**Re: University Station  
Response to Utility Review Comments**

Tetra Tech has completed our review of the comments provided by BETA Group dated April 4, 2013. For ease of review, responses are numbered to coincide with the numbering system utilized in the original letters. Responses are shown in *italic* font.

**April 4, 2013 Correspondence from BETA Group**

**S-G1**  
Bar Measures 1 inch

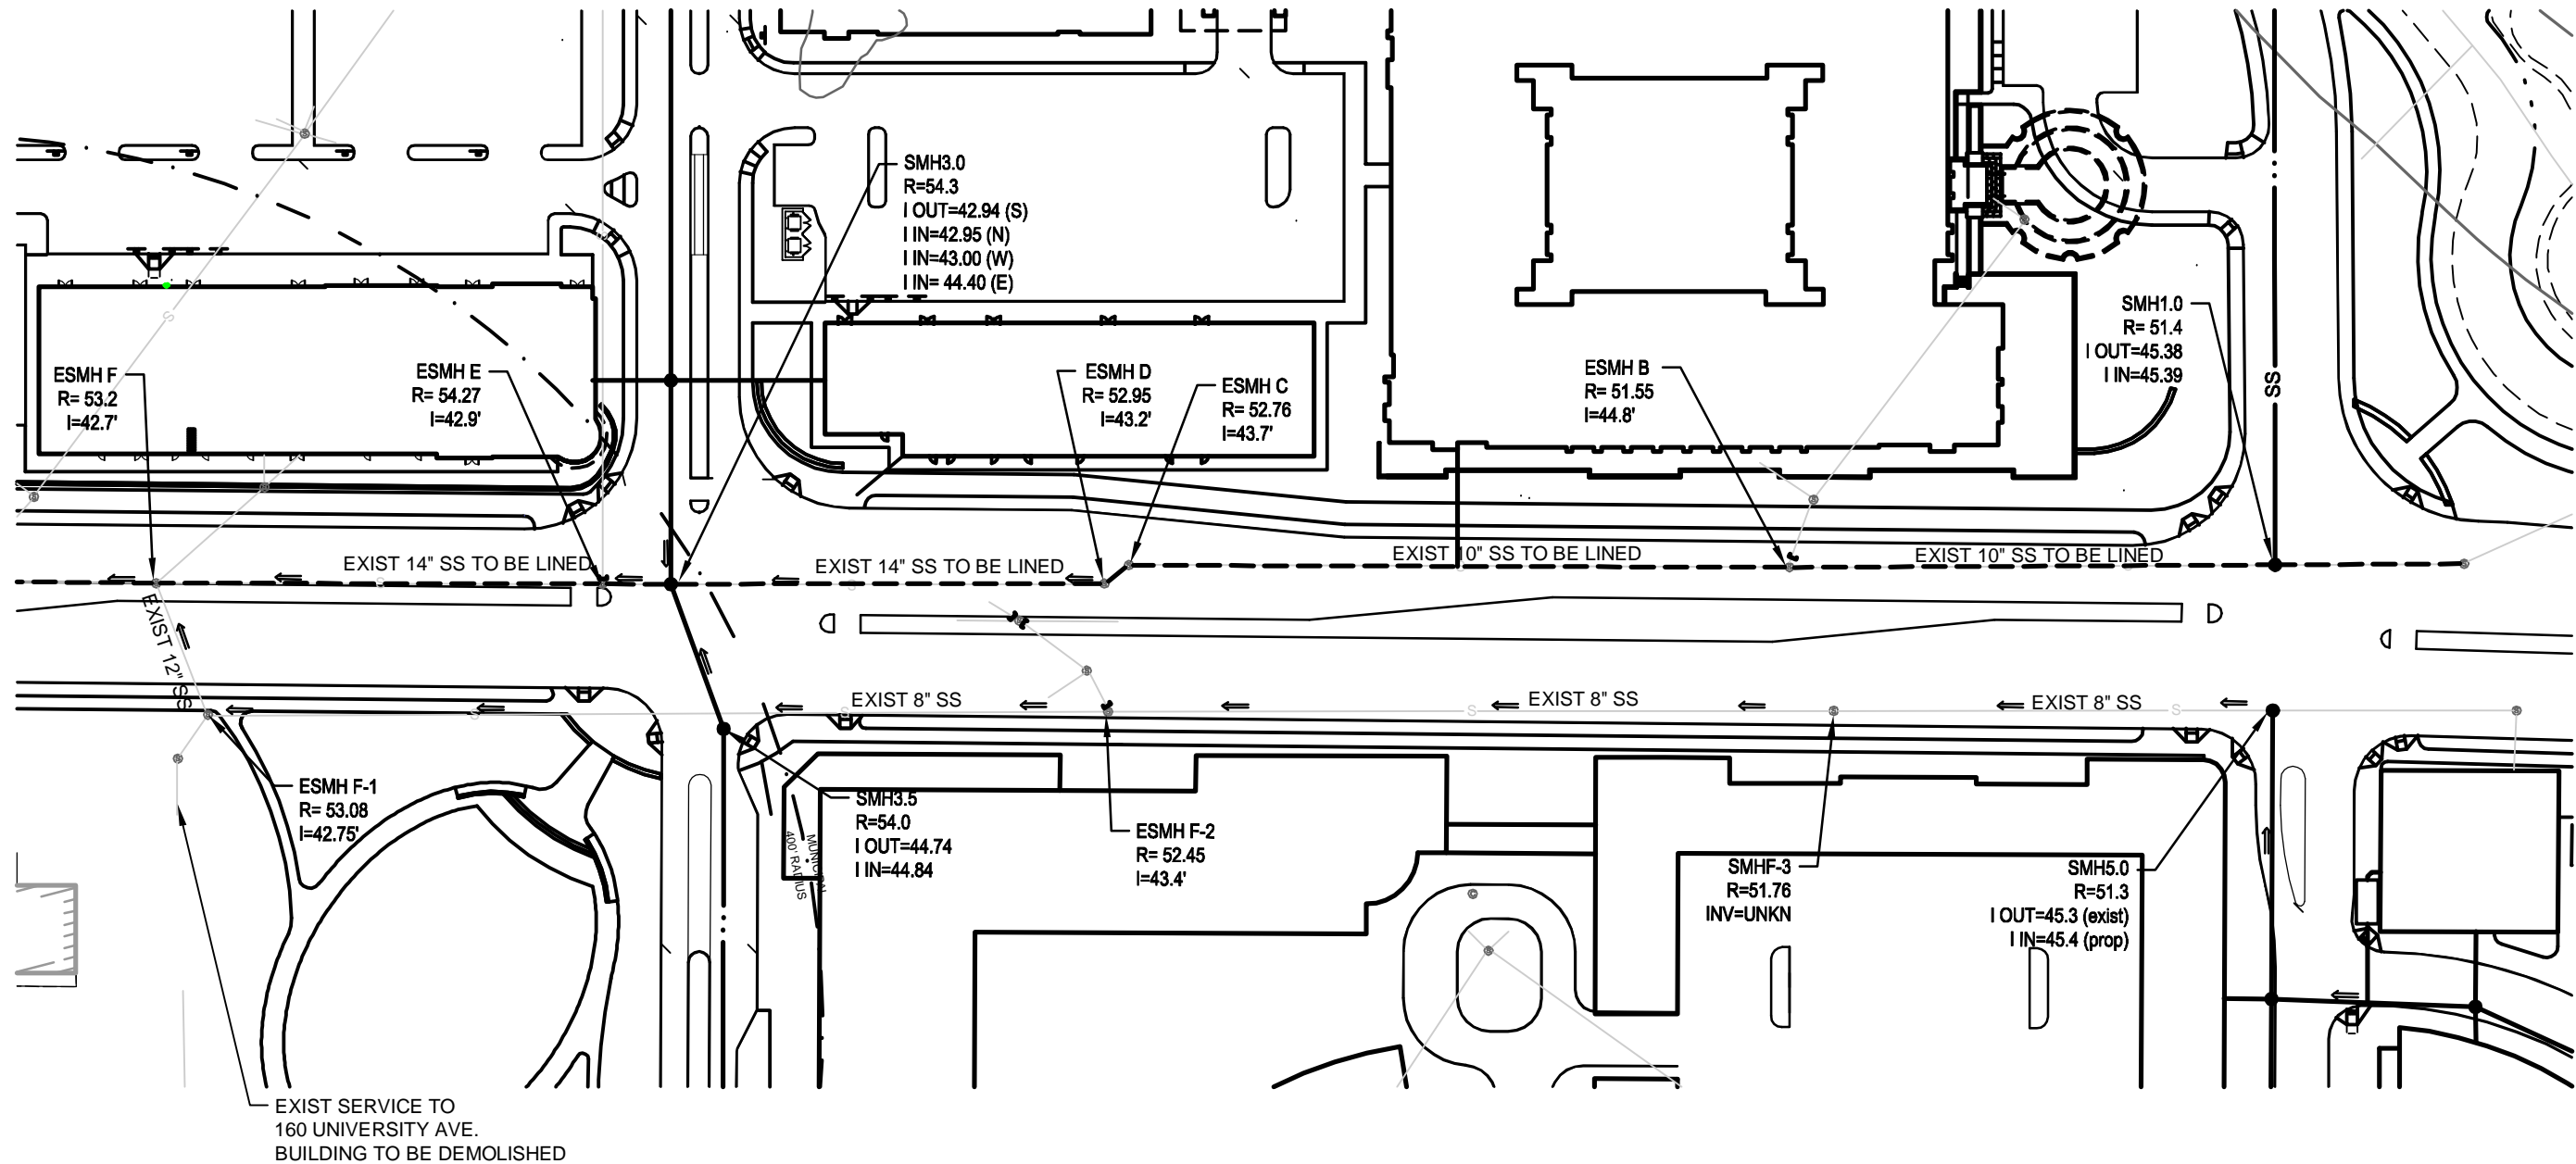
**Comment 5:** The existing sewer running cross country to the south west of Harvard Street (sheet C-114/124) needs to be moved to be outside the extents of the proposed detention pond area.

***Response:*** *The existing cross country sewer will be relocated outside of the proposed detention pond area. A sketch of the proposed relocation is attached.*
